To: T10 Technical Committee  
 From: Rob Elliott, HP (elliott@hp.com)  
 Date: 22 October 2003  
 Subject: 03-346r0 SAS-1.1 Pathway recovery priority corrections

A few deadlock scenarios have been discovered and a few rules regarding pathway recovery have been proven to be unclear. They mostly relate to this paragraph in 7.12.4.4:

Figure 1 — Highest priority request is blocked

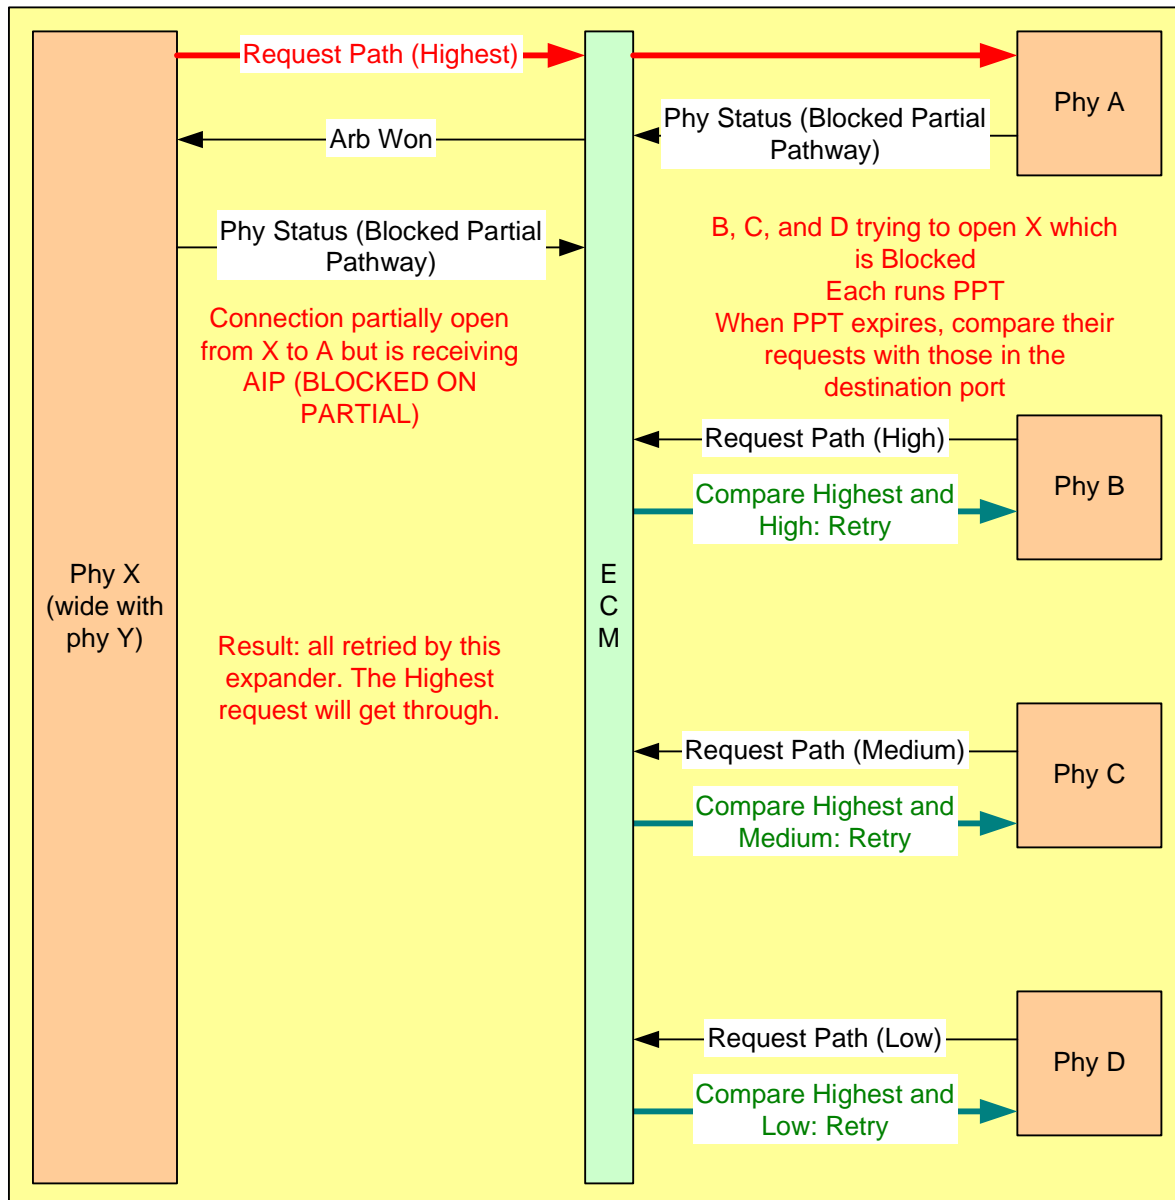
Figure 1 shows a situation where the highest priority request is a blocked partial pathway. No changes are proposed; this just emphasizes that three independent comparisons (B to X, C to X, D to X) are run, not one comparison (B to C to D to X),

Figure 2 — Lowest priority request is blocked

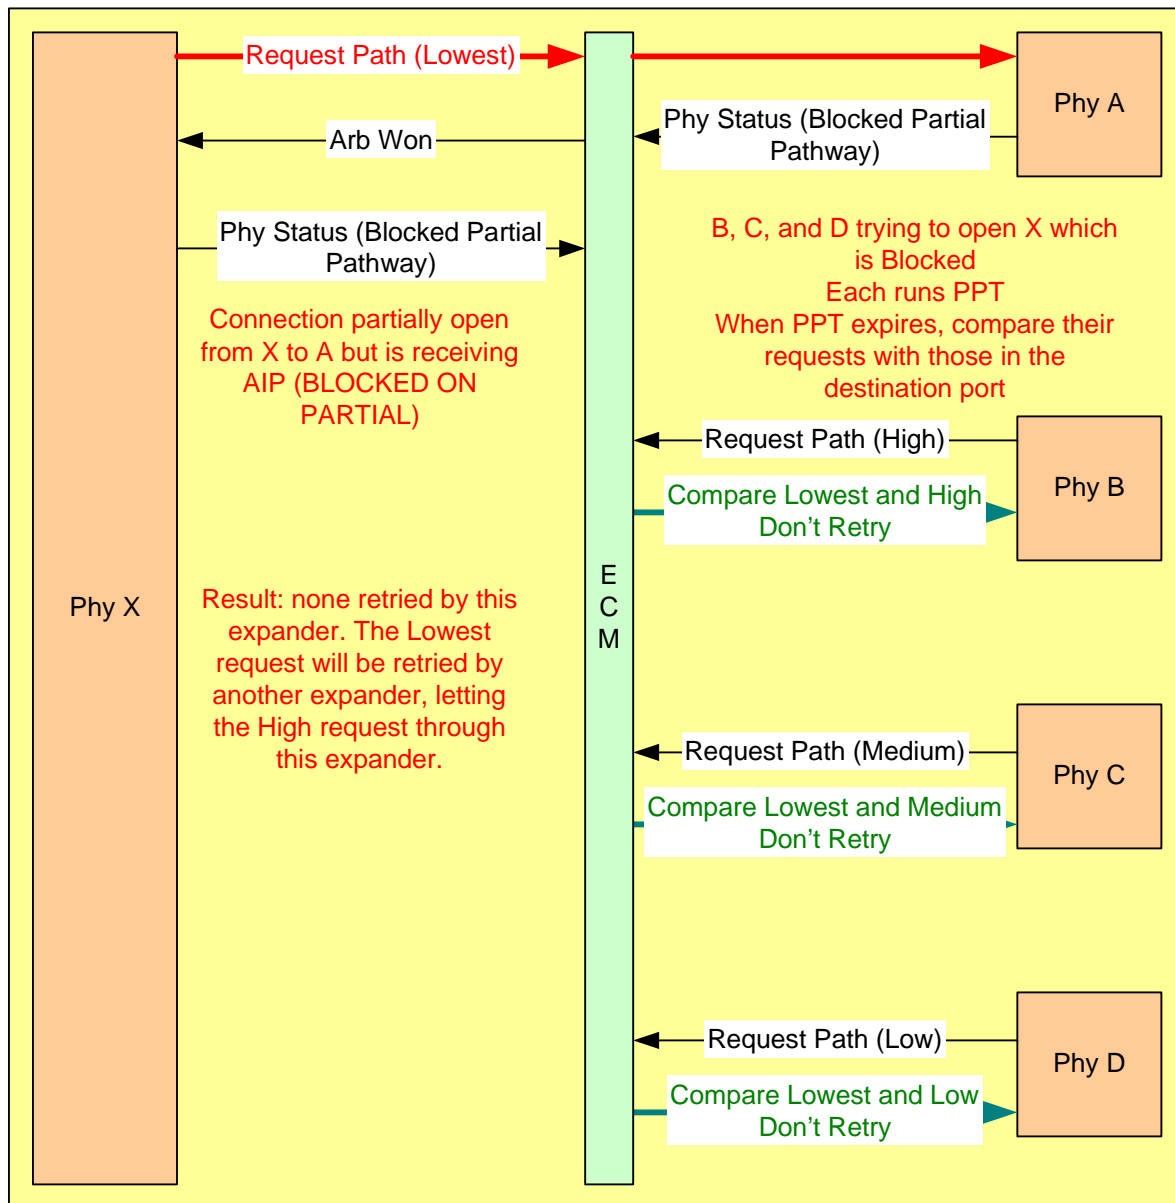
Figure 2 shows a situation where the lowest priority request is a blocked partial pathway. No changes are proposed; this just emphasizes that three independent comparisons (B to X, C to X, D to X) are run, not one comparison (B to C to D to X).

Figure 3 — All vs any

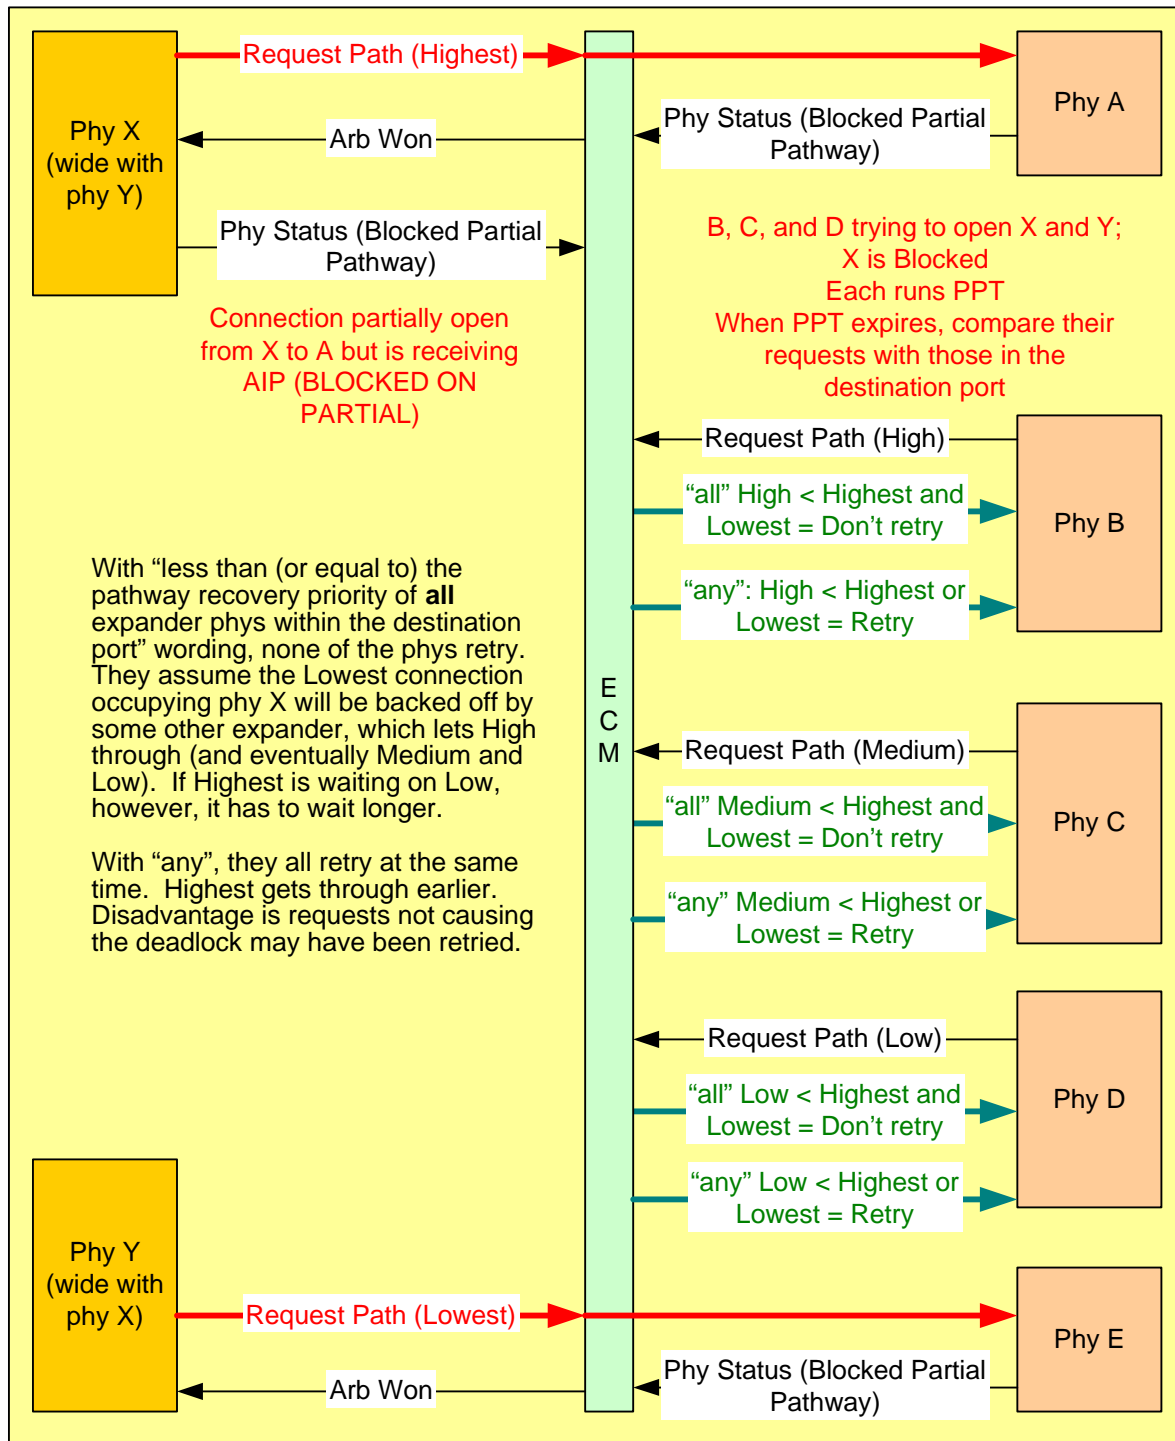
Figure 3 shows the effect of comparing “all” vs any” when the destination is a wide port. The current rule is “all”; “any” is proposed instead to resolve deadlocks faster (at the expense of more retries).

- the Partial Pathway Timeout timer expires; and
- the pathway recovery priority of the arbitrating expander phy (i.e., the expander phy requesting the connection) is less than or equal to the pathway recovery priority of ~~all~~ any of the expander phys within the destination port ~~with an arbitration status of WAITING\_ON\_PARTIAL~~ that are sending Phy Status (Blocked Partial Pathway) responses to the ECM.

Figure 4 — Less than or equal

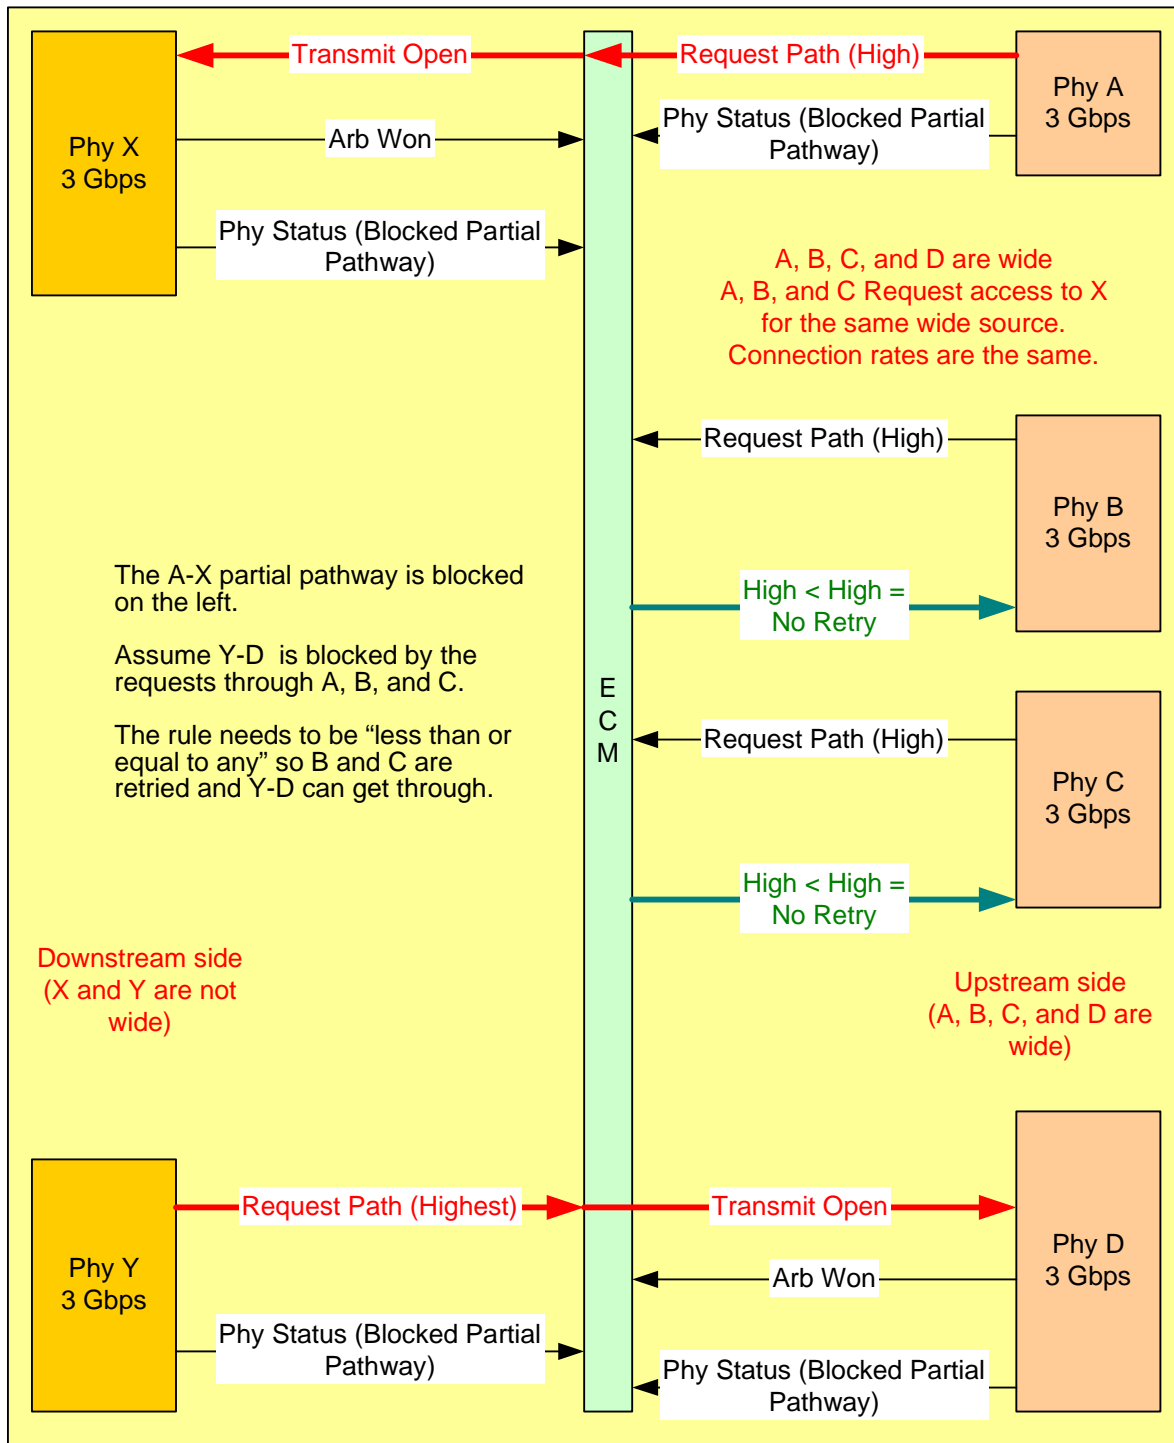
Figure 4 shows a case where the source addresses in pathway recovery priority comparisons are the same, so “less than or equal” is needed rather than “less than”.

Figure 5 — Connection rate example

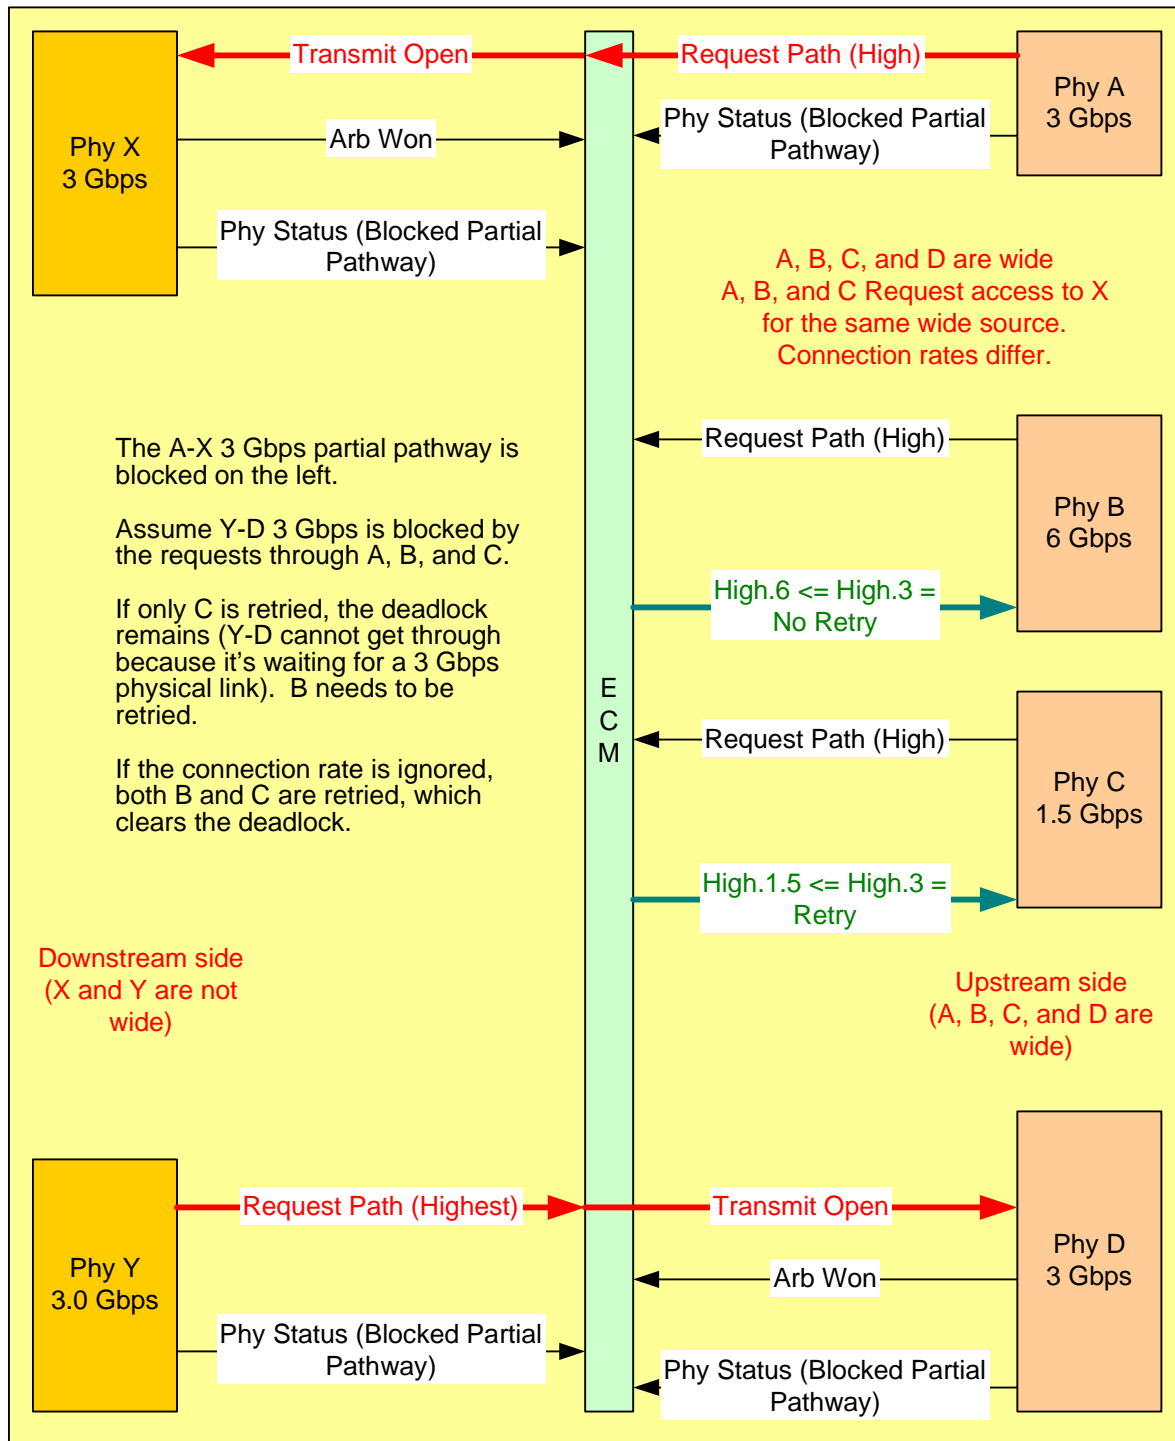
Figure 5 shows a case where the connection rate needs to be ignored or the connection retried might not break a deadlock.

Bits <del>75-68</del> 71-64 ( <del>75</del> 71 is MSB)	Bits <del>67-5</del> 63-0 (0 is LSB)	<del>Bits 3-0 (0 is LSB)</del>
PATHWAY BLOCKED COUNT field value	SOURCE SAS ADDRESS field value	<del>CONNECTION-RATE field value</del>

Figure 6 — Add Arb Status (Normal) to Phy Status (Blocked Partial Pathway) equation

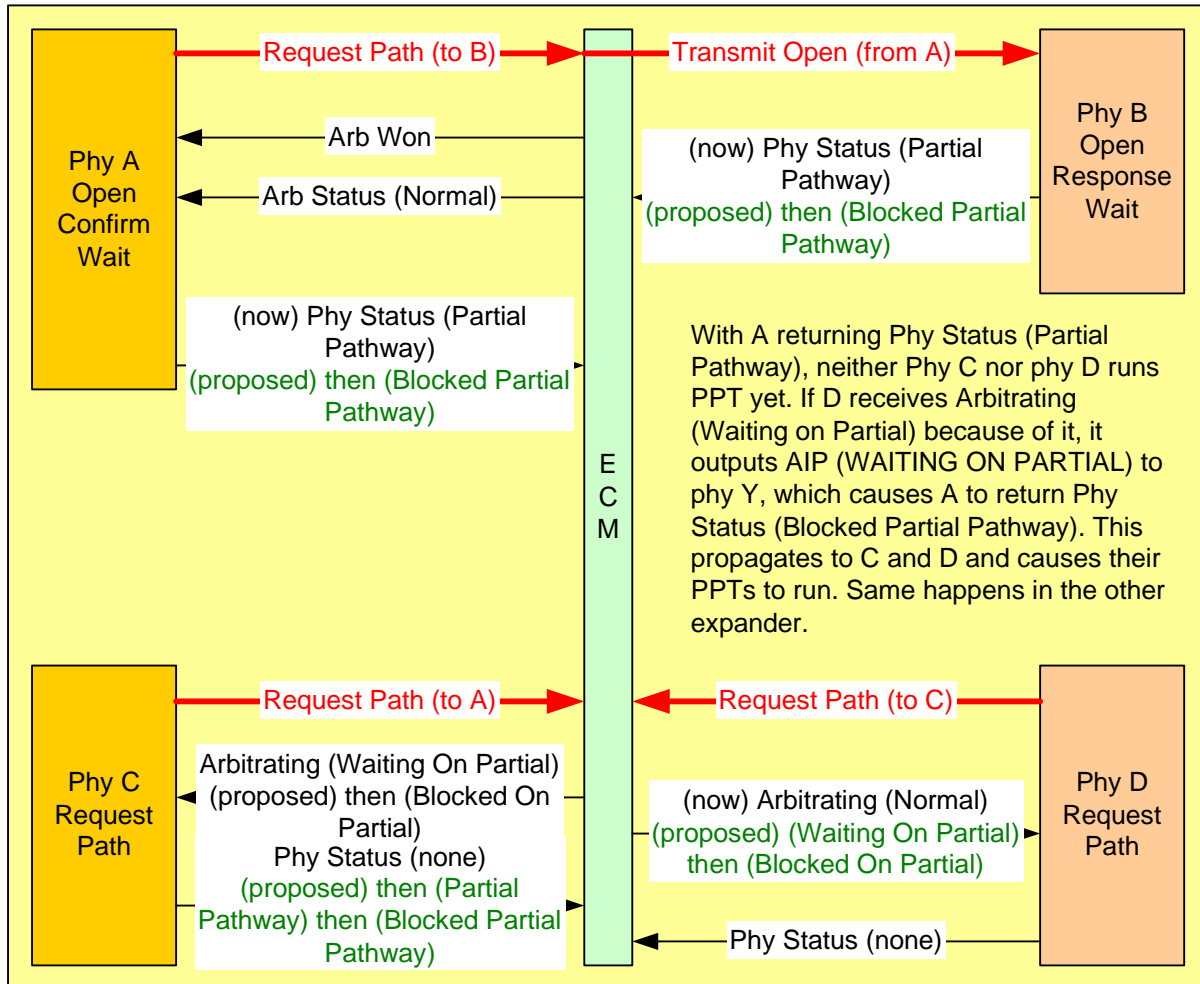
Figure 5 shows a case where Phy Status (Partial Pathway) and Phy Status (Blocked Partial Pathway) need to be forwarded from phy to phy.

Left-side expander close-up (right side is just a mirror image of this):
